Service Bulletin No. 386

MODEL E4500 / J4500 Series Coaches	TYPE Field Change Program	SECTION/GROUP 6-Cooling	DATE June 1, 2012
SUBJECT FAN CLUTCH BUSHING			
CONDITIONS

Figure 4.

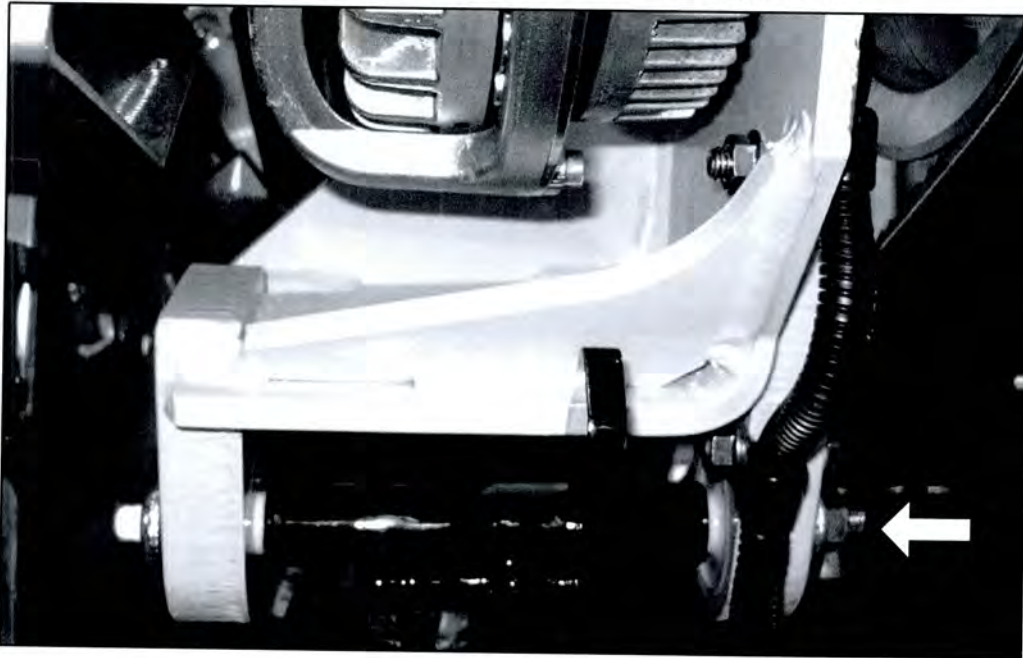
8. Locate the fan clutch bracket mounting bolt, at the base of the assembly (refer to Figure 4).
9. Remove and discard the fan clutch bracket mounting bolt and mounting hardware.

Figure 5.

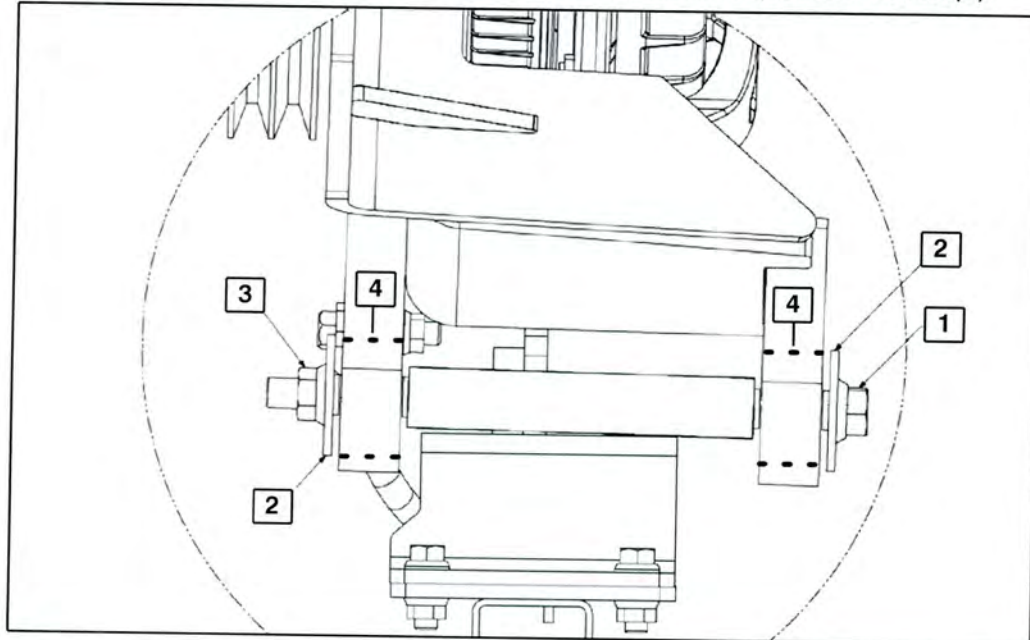
Motor Coach Industries ("MCI") has become aware that the fan clutch bracket bushing on certain E4500 and J4500 coaches may walk out of the bracket, which may allow clutch mis-alignment and belt failure.

The cause is due to the absence of a washer.

MCI strongly encourages owners of the E4500 and J4500 model coaches listed in the table below to replace the fan clutch bracket mounting hardware by implementing the steps in this procedure as soon as possible.

10. Orient and install new capscrew, p/n 19-01-1518, washers, p/n 19-02-0388, and nut, p/n 19-03-0497 as shown in Figure 5. Tighten nut to secure installation (the nut will be torqued at a later step).

ITEM	DESCRIPTION
1	Capscrew
2	Washer
3	Nut
4	Bushing

11. Orient and re-install the belt on the fan clutch pulley.
12. Torque the nut, p/n 19-03-0497, to 80–88 ft-lbs.
13. Carefully release the tension from the ratchet strap compressing the shock.
14. Close the engine compartment door.
